## Letter 70 cont'd

**LETTER 70: BOOTH, SEAN**

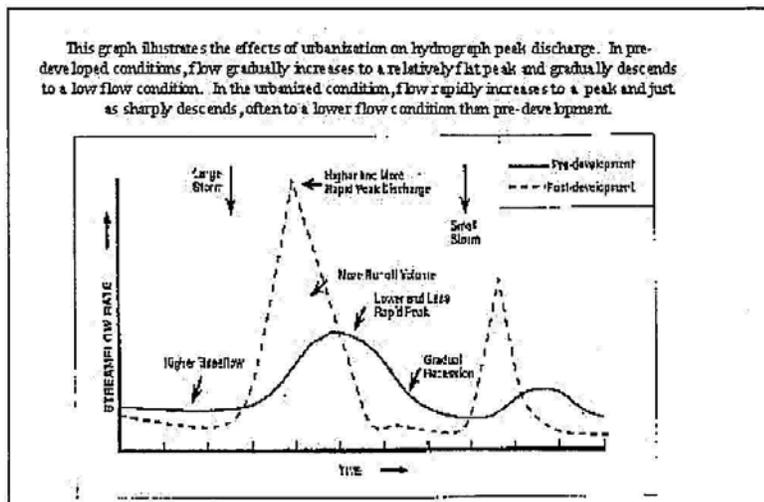
- b. Where is a hydrological graph in the DEIR, such as below to explain the hydrologic modeling and flow? Graphs people can better understand and critique. Models (such as HEC-1) are too abstract for ordinary reviewers, including myself and the city council members. While the models may be valid, it only looks at the Dry Creek watershed as a whole, not this specific location and tributary. Please include sections of the Placer County Flood Control's "Dry Creek Watershed Flood Control Plan" in this DEIR as well as comprehensive translation of the findings.

- c. Why does the DEIR not make it transparent and graphical as to the hydrological / flooding effects with added IC? (See rough example below)

- b. The data represented by the requested graph is fundamental and included in the hydrologic modeling performed to analyze the project's hydrologic impacts.

- c. The data represented by the requested graph is fundamental and included in the hydrologic modeling performed to analyze the project's hydrologic impacts.

Showing: location of Bickford in relationship to Clover Valley

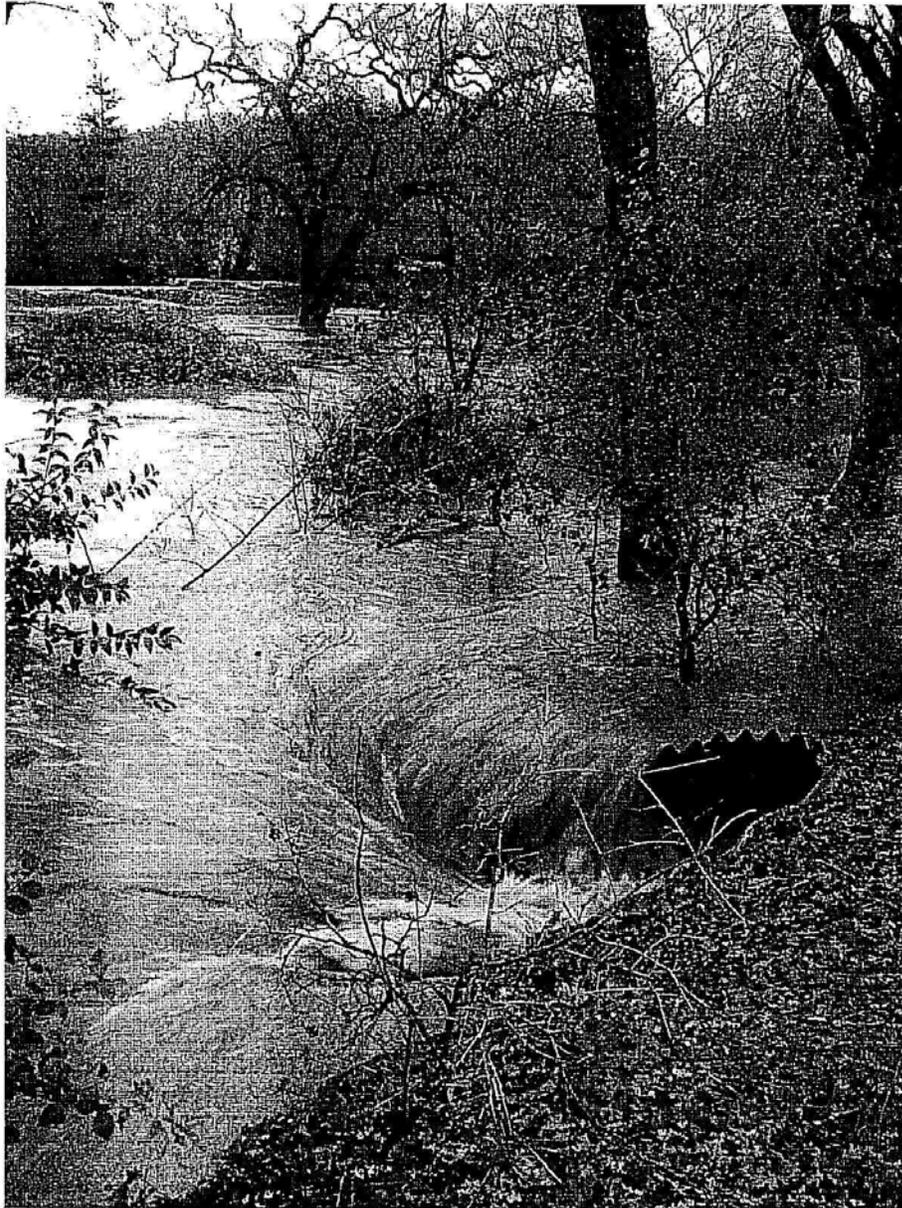
- What are all of the inputs to the model? Given the unique nature of this small, narrow canyon, hard bedrock and volcanic lahars -- a generic watershed analysis is completely inadequate.
- What is the methodology of this model? There are no details provided to critique this methodology.
- Regarding Storm Drain Systems D, G, H, J and P, where is this water going? How will impact Antelope Creek both qualitatively and quantitatively?
- Has the run-off from Bickford Ranch been researched and incorporated? See attached map of watershed, topography and projects. Bickford clearly is in the upper reaches of this watershed. (Source: 3)
- Has Placer County Flood Control District researched the impacts of Bickford Ranch impervious cover?

- up to 10 cfs of flow to Clover Valley Creek, and this flow should be included in future watershed modeling.
- f. See Master Response 11.
  - g. See Master Response 11. All of the houses along the creek are planned to be above the 100-year water level
  - h. See Master Response 11.
  - i. Since no special status fish species were found to be present in Clover Valley Creek, the implementation of the project is not required to mitigate for future speculative impacts.
  - j. Technical Appendix O presents the hydrologic modeling for the project.

Clover Valley Park (adjacent to Midas Street), Dec. 2005

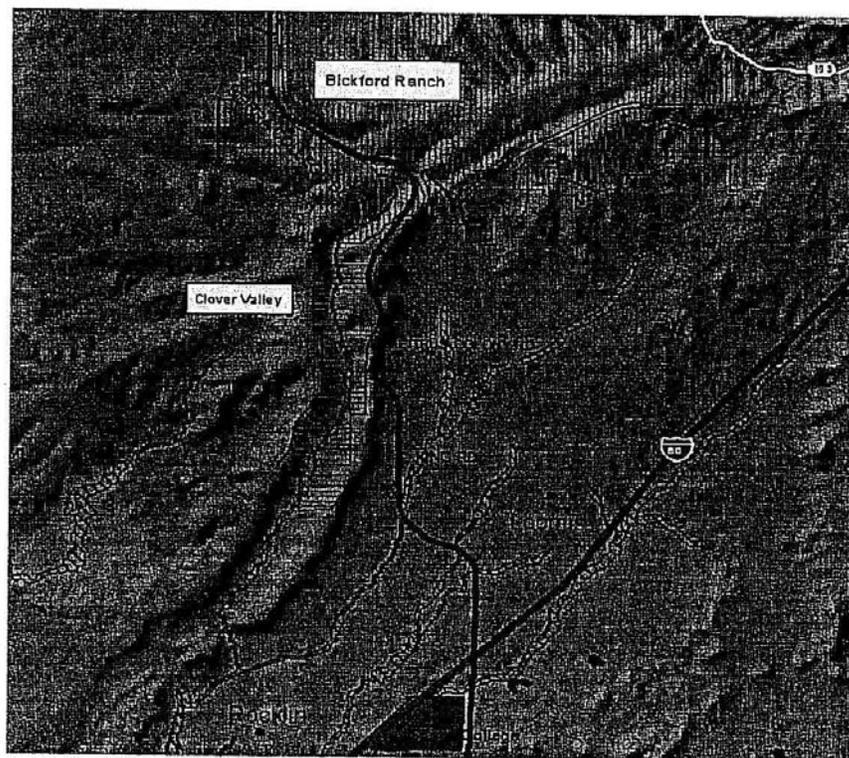
The City of Rocklin needs to take a serious look at this extremely engineered and over-built project. Members of the council and others need to scrutinize the impacts of this project on the upper watershed, especially given the current conditions downstream, which flood frequently. On Dec. 31 significant flooding occurred downstream, yet this storm event was not an extreme event. The 100 year event would be much larger, and if nothing were built upstream, the downstream flooding would have been much worse. Home owners adjacent to the floodplain have a right to know a more detailed analysis of the hydrological impacts from this large-scale project upstream. Adding all of the structures, roads, engineered water works will surely only aggravate the situation.

The commenter states that significant flooding occurred downstream from the proposed project on December 31, 2005, also noting that, “if nothing were built upstream, the downstream flooding would have been much worse.” The commenter’s point is accurate in that the construction of improvements such as the detention basins included in the proposed project, would increase flood controls along the Clover Valley Creek and act as a controlling factor in extreme weather events and would result in more controlled flows during extreme storms, such as the 100-year flood event. Table 4.11-2 illustrates that the proposed project would be expected to result in a small decrease in floodwater flows during the 100-year flood event at all locations as well as a decrease in peak flows during the 2-year and 10-year storm event scenarios at all locations with the exception of Dry Creek at the Natomas East Main Drainage Channel which would have slight increases (14 cfs in the 2-year storm event and 1 cfs in the 10-year storm event).
